PARTS & SERVICE NEWS

REF NO.	AA01033
DATE	January, 28, 2001

SUBJECT: 930E FUEL AND HYDRAULIC TANK MOUNTING CRACKS

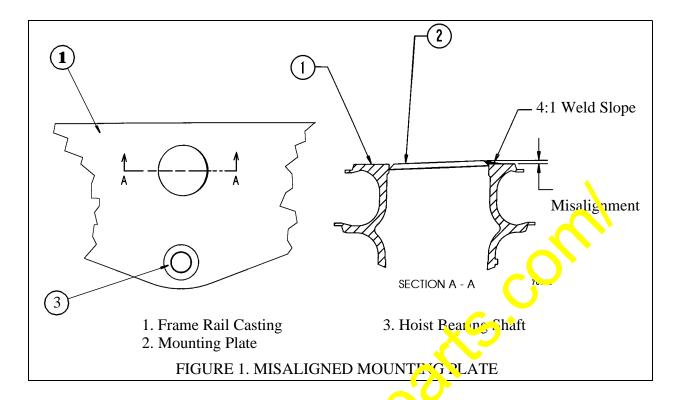
- 1. Remove the hydraulic tank and the fuel tank from the truck. Refer to the appropriate shop manual for the proper procedures.
- 2. Determine whether misalignment exists between tank mounting plate (2, Figure 1) and frame rail casting (1). The tank mounting plate may not be flush with the casting. Refer to Figure 1. If any cracks exist in the misalignment region, the crack repair weld should be tapered to the casting using a 4:1 slope, as shown. Grind the weld toe to make a smooth transition to the frame rail.

NOTE: Mounting plates (2) are only located at the tank mounts hat are directly above hoist bearing shafts (3). Therefore, inspections and repairs must be performed at each location.

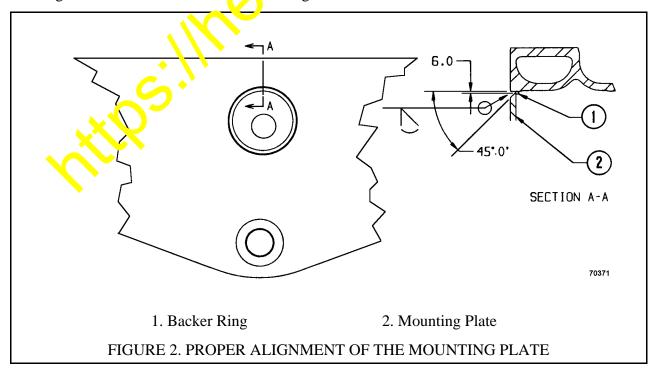
3. If cracks are present and tank mounting plate (2) is flush with casting (1), the plate must be removed. After the plate has been removed clean all foreign material, weld debris, etc. from the plate and from backer ring (1, Figure 2). In stall plate (2) flush with backer ring (1). Ensure that the mounting plate is flush with the flare rail casting. It may be necessary to reposition the backer ring. The slotted section of the packer ring should face the rear of the truck.

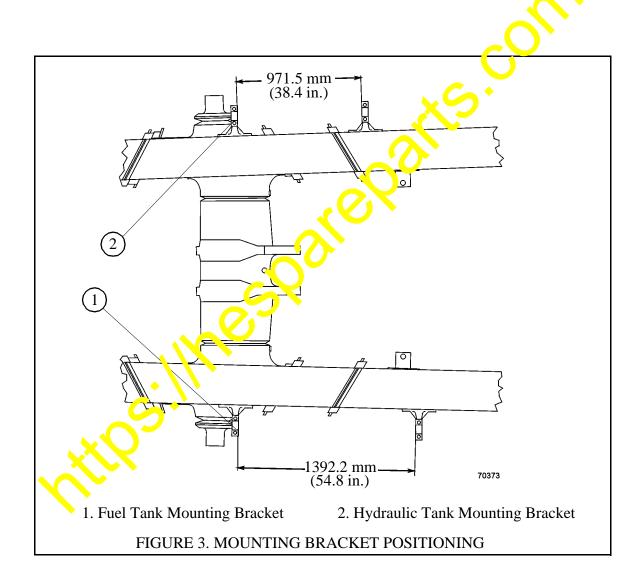
4. If the mounting plates were removed, ensure that mounting brackets (1 & 2, Figure 3) are perpendicular to the ground and are positioned at the correct distances upon installation. It may be necessary to temporarily lift the tanks into position above the mounts to ensure proper alignment.

If the mounting brackets are not correctly positioned, proper installation of the tanks may not be attainable.
